Duke Energy Ohio Case No. 19-2163-EL-BLN STAFF Third Set of Data Requests Date Received: January 27, 2020

STAFF-DR-03-001

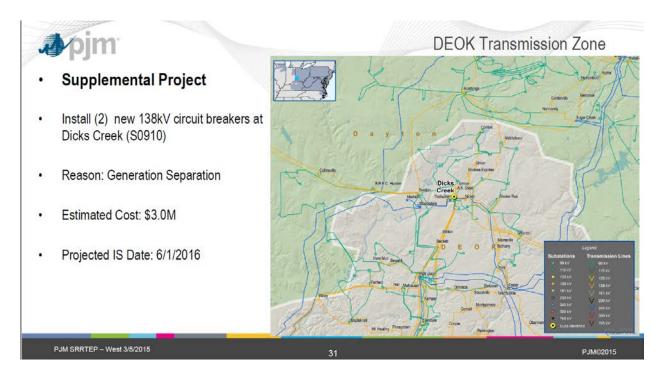
- 1. Please send us:
 - a) a switching diagram and
 - b) the latest S0910 presentation slides at the PJM RTEP.
- 2. Please explain why the 138kV lines need to be reconductored.

- 1.(a) The requested switching diagram is Confidential Energy Infrastructure Information that, under the terms of a confidentiality arrangement, Duke Energy Ohio may not release. The OPSB will need to go through PJM's CEII process, as required by FERC.
- 1.(b) The PJM slides are found on the web here: https://www.pjm.com/-/media/committees-groups/committees/srrtep-w/20150305/20150305-reliability-analysis-update.ashx; at page 31. For convenience, a screenshot is reproduced below.
